Extrapolation For Bin16

In support of comment #R2-191

Amir Rubin, Nvidia

Current Extrapolation for bin 16

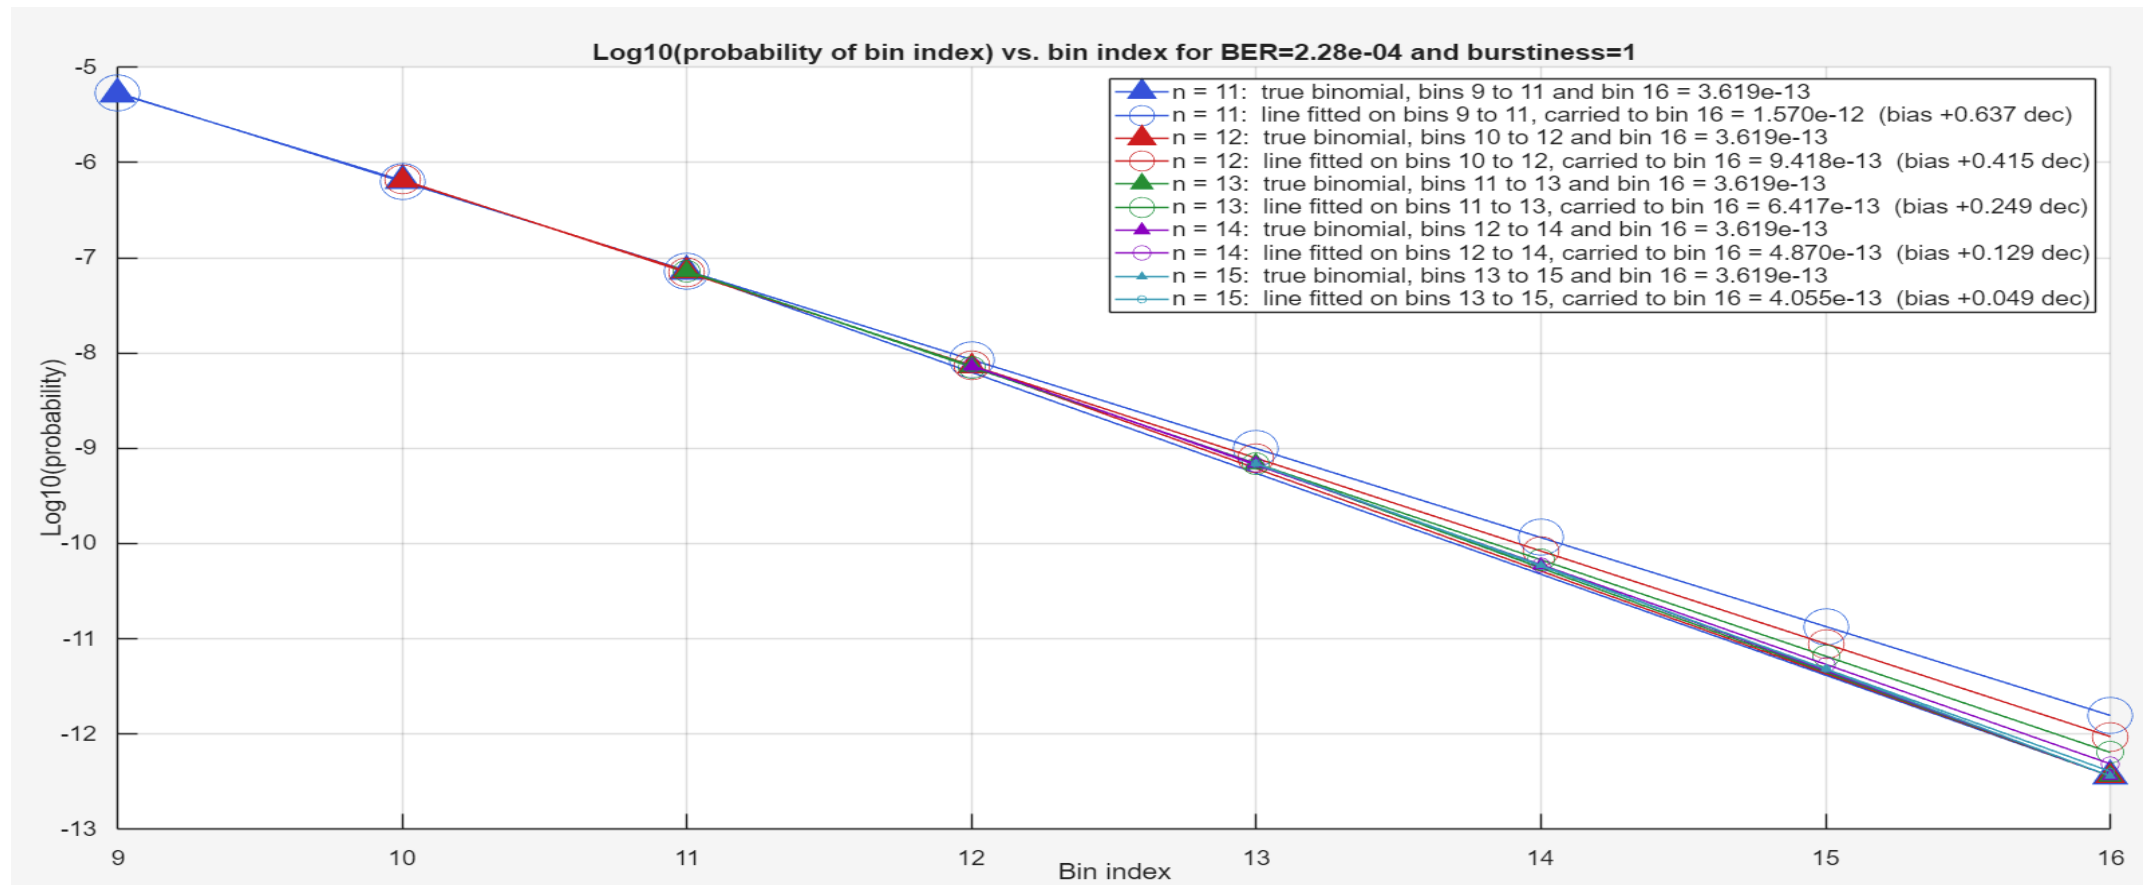
- Quotation from 180.9.14 Receiver sensitivity, page 492 :

"NOTE—In order to predict whether a receiver meets the BLER requirement in a short test time, extrapolation of the measured histogram (see 174A.9.3) to $H_m(16)$ can be performed. One way of doing this is using a linear fit of $\log_{10}(H_m(k))$ for $k = (n - 2)$ to n , where these values of k are the three highest bins having a count of 10 or more. If the slope of the histogram over the measured bins is increasing, it might be an indication of not meeting the BLER requirement. To verify that the slope is not increasing, the values of $(\log_{10}(H_m(k)) - \log_{10}(H_m(4))) / (k - 4)$ should be less than $(\log_{10}(H_m(4)) - \log_{10}(H_m(2))) / 2$ for each k greater than 4."

- However, the linear model of $\log_{10}$ of portion of uncorrelated errors is:
 - Biased towards false failures
 - With excessive scatter over random scenarios

180.9.14 log10 linear model distribution (1)

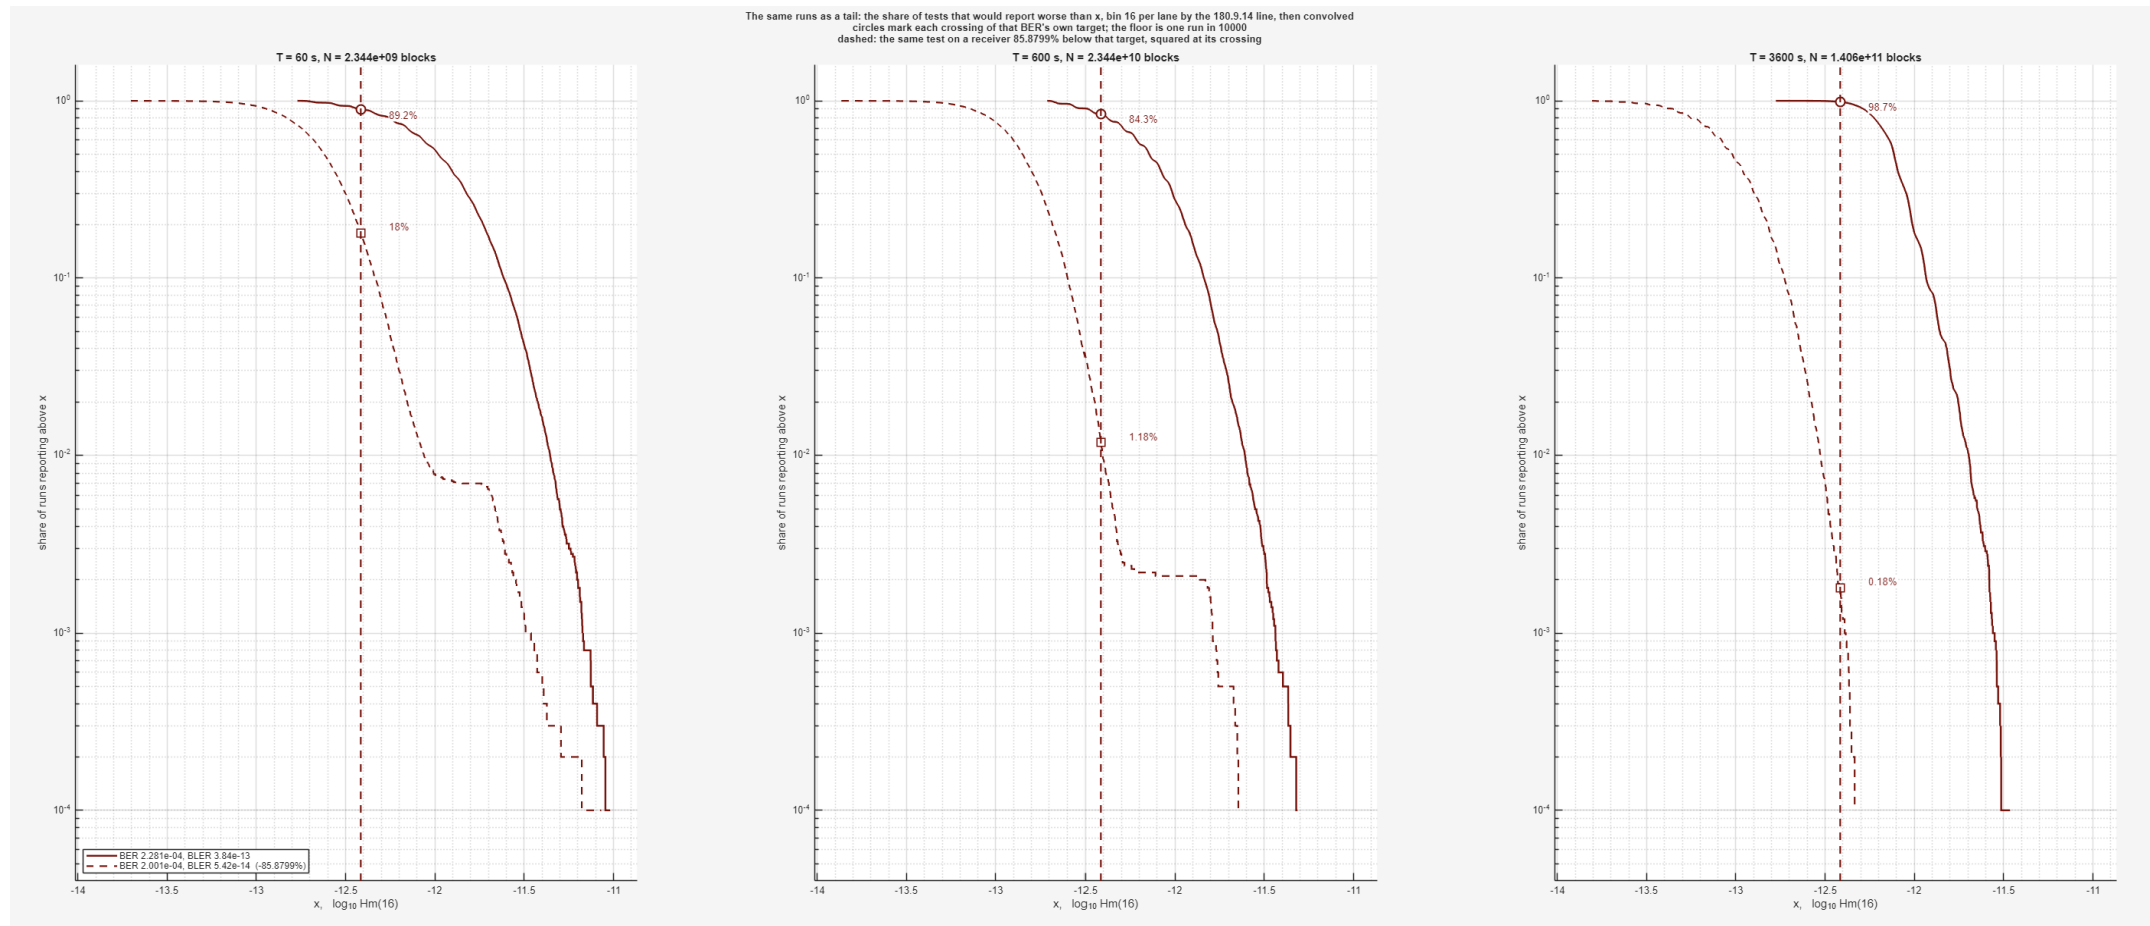
Target BER=2.28e-4, leading to BLER=3.84e-13, vs. BER=2.0e-4 leading to BLER=5.42e-14 (-85.9%)

- Wide scatter over random scenarios, based on Monte Carlo draws
- Probability of more than 80% for failure of marginal links (uncorrelated BER of 2.281e-4), that should pass with 50%
 - For duration of 60[Sec], there's ~18% for false failure for links with uncorrelated BER of 2e-4, that should always pass
- The figures below show the CCDF (Complementary CDF = probability of X value and above/worse) of current extrapolation scheme for 1X links

180.9.14 log10 linear model distribution (2)

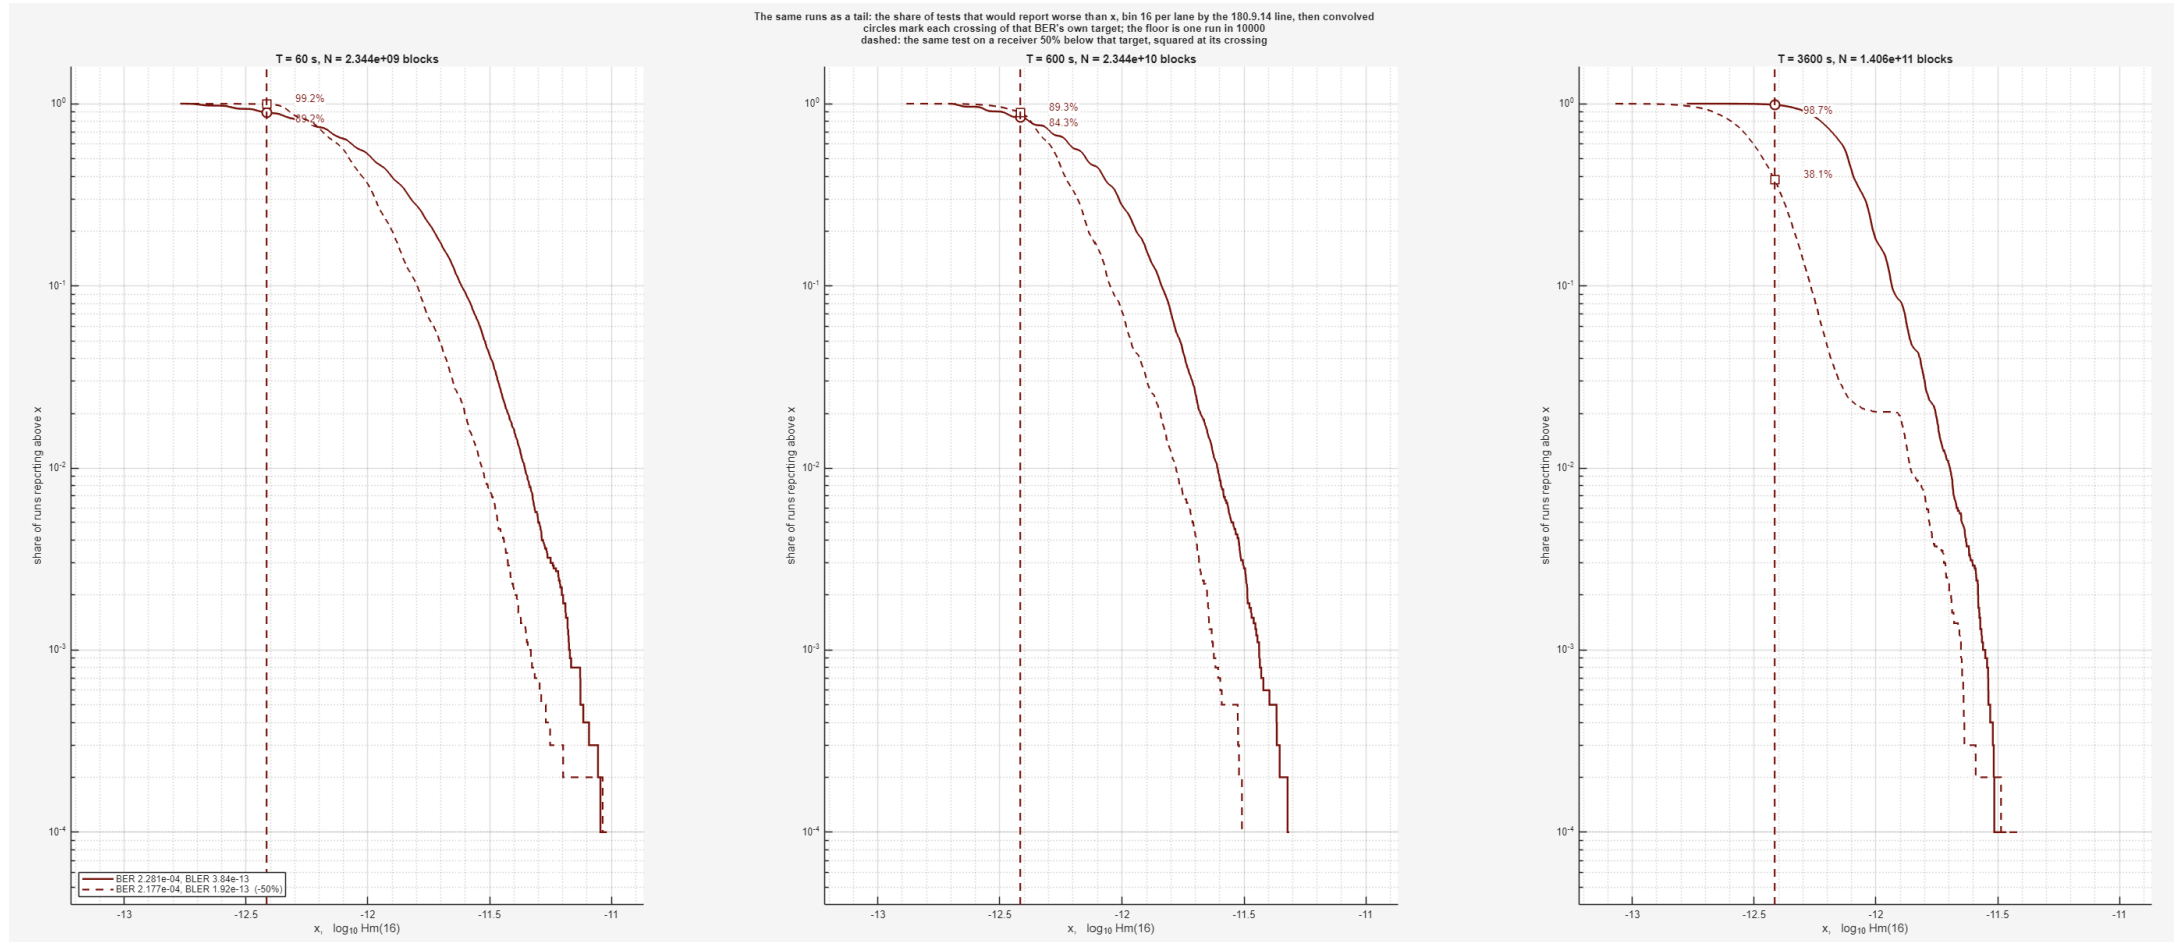
Target BER=2.281e-4, leading to BLER=3.84e-13, vs. BER=2.177e-4 leading to BLER=1.92e-13 (-50%)

- High probability of false failure for links with BLER that is 50% lower than target (1.92e-13), that should always pass
- The figures below show the CCDF (Complementary CDF = probability of X value and above/worse) of current extrapolation scheme for 1X links

Proposed Remedy – Model

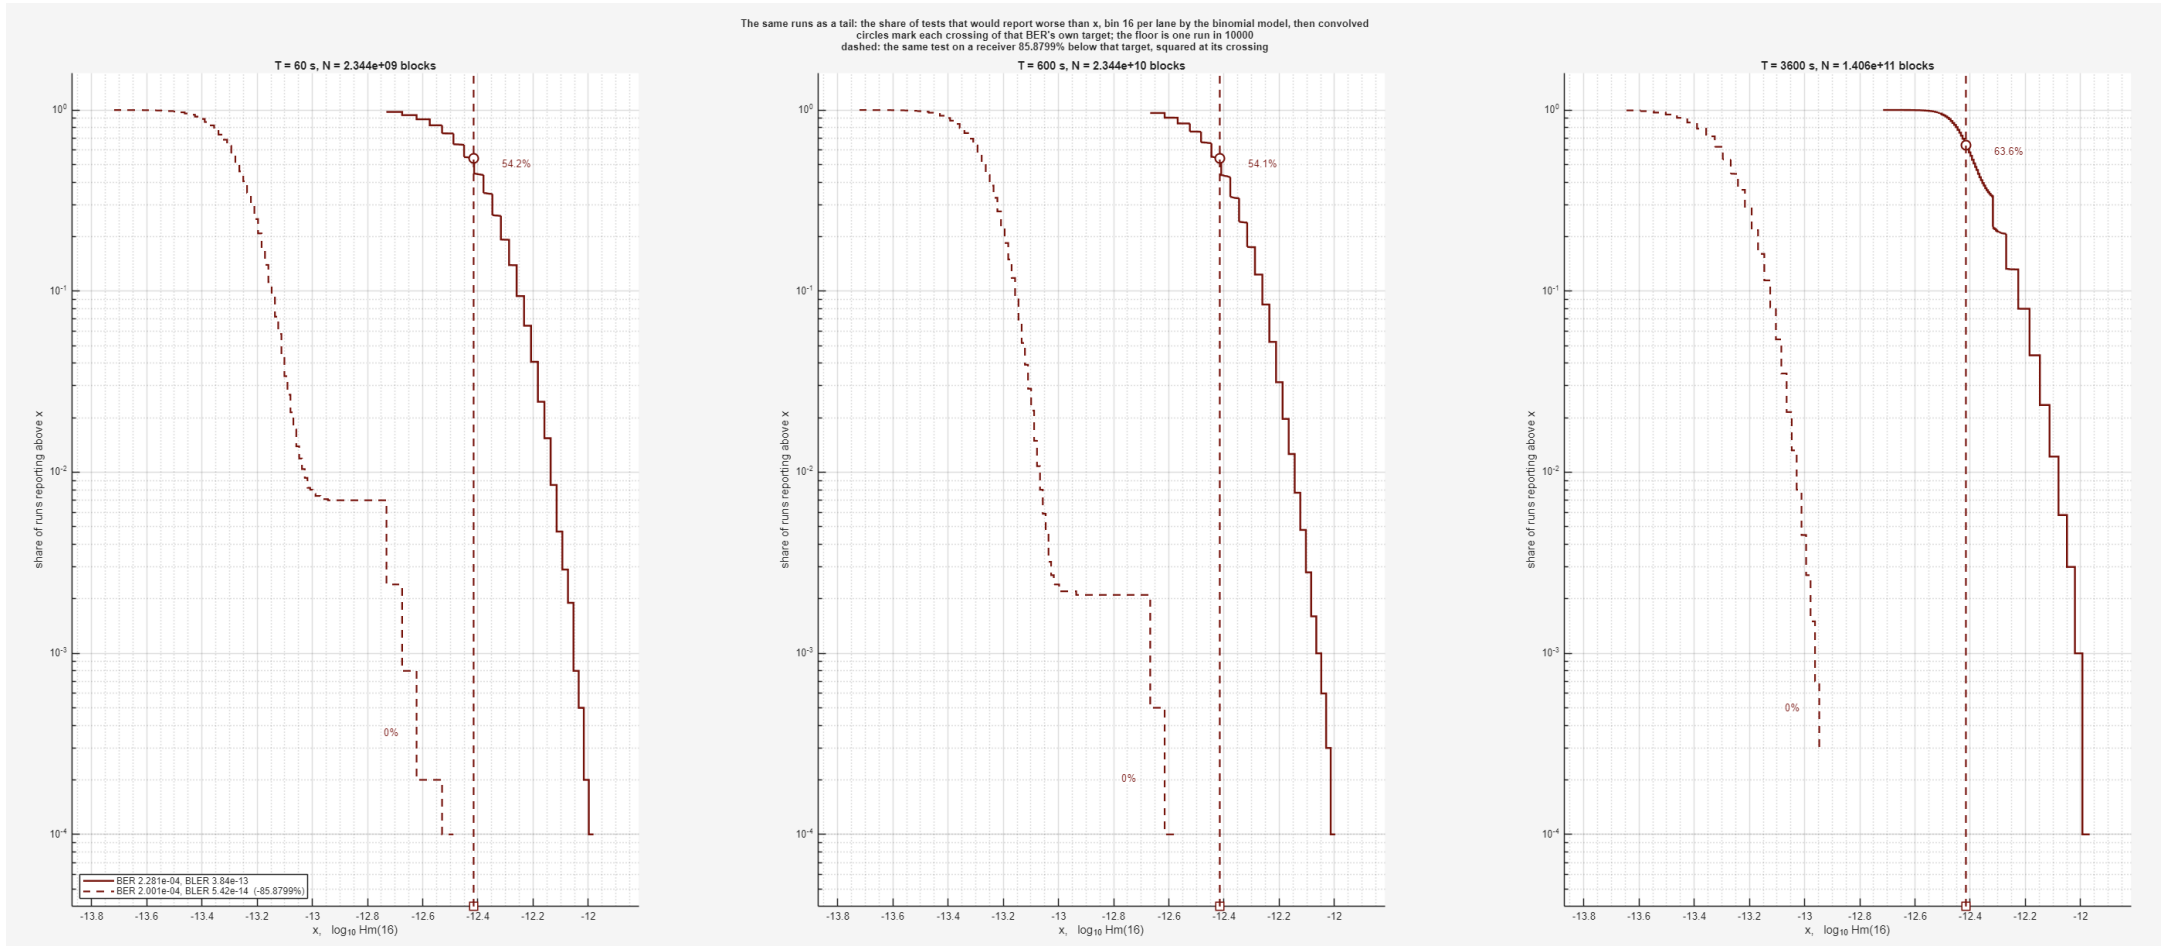
Use directly the binomial distribution function which has no bias

- Equivalent RSSER(k): The RSSER for which the portion of histogram k fits the binomial distribution function

- Find Equivalent RSSER for max nonzero histogram with count of 10 or more

- Extrapolated bin 16 = $\sum_{k=16}^{544} \frac{544!}{k!(544-k)!} \text{Equivalent RSSER}^k (1 - \text{Equivalent RSSER})^{544-k}$

- Alternatively see if the following is satisfied for max nonzero histogram k with count of 10 or more

Proposed remedy binomial model distribution (2)

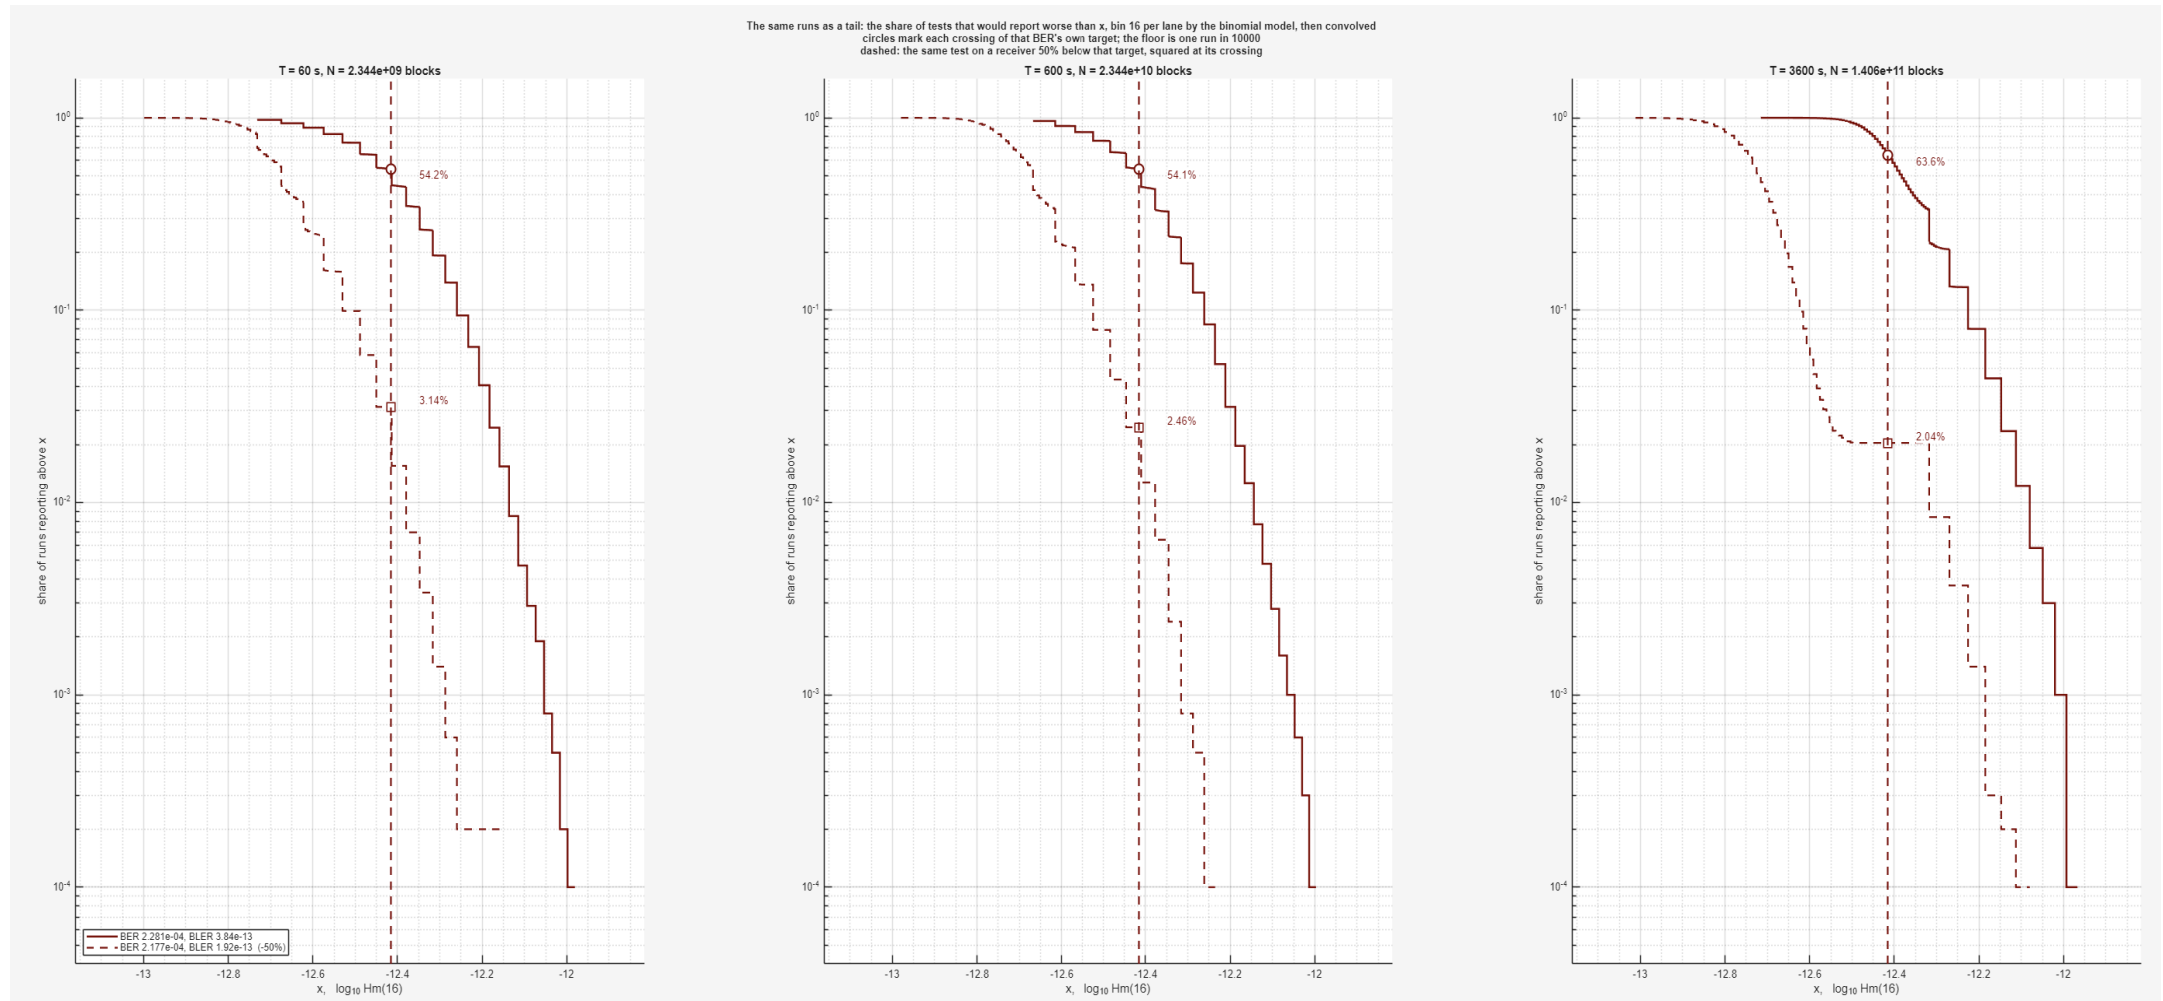
- Very meaningful drop of the probability of false failure for links with BLER that is 50% lower ($1.92\text{e-}13$), equivalent to $0.032[\text{dB}]/0.016[\text{dBo}]$ margin
- The figures below show the CCDF (Complementary CDF = probability of X value and above/worse) of the proposed extrapolation scheme for 1X links
